City of Mississauga Department Comments

Date Finalized: 2022-09-14 File(s): A405.22

The applicant requests the Committee to approve a minor variance to allow an existing driveway with a width of 5.2m (approx. 17ft) whereas By-law 0225-2007, as amended, permits a maximum driveway width of 4.44m (approx. 14.5ft) in this instance.

Property Address: 1169 Barnswallow Crt

Appendix 1 – Transportation and Works Comments

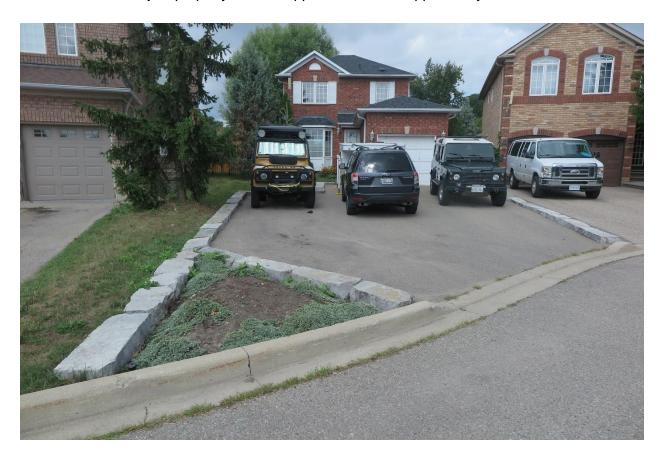
This department notes that with regard to the widened driveway within the municipal boulevard (the area between the municipal curb and property line) we would request that this area be reinstated with topsoil and sod should the application be modified to reflect a smaller driveway width within the subject property or if the application is not supported by the Committee.
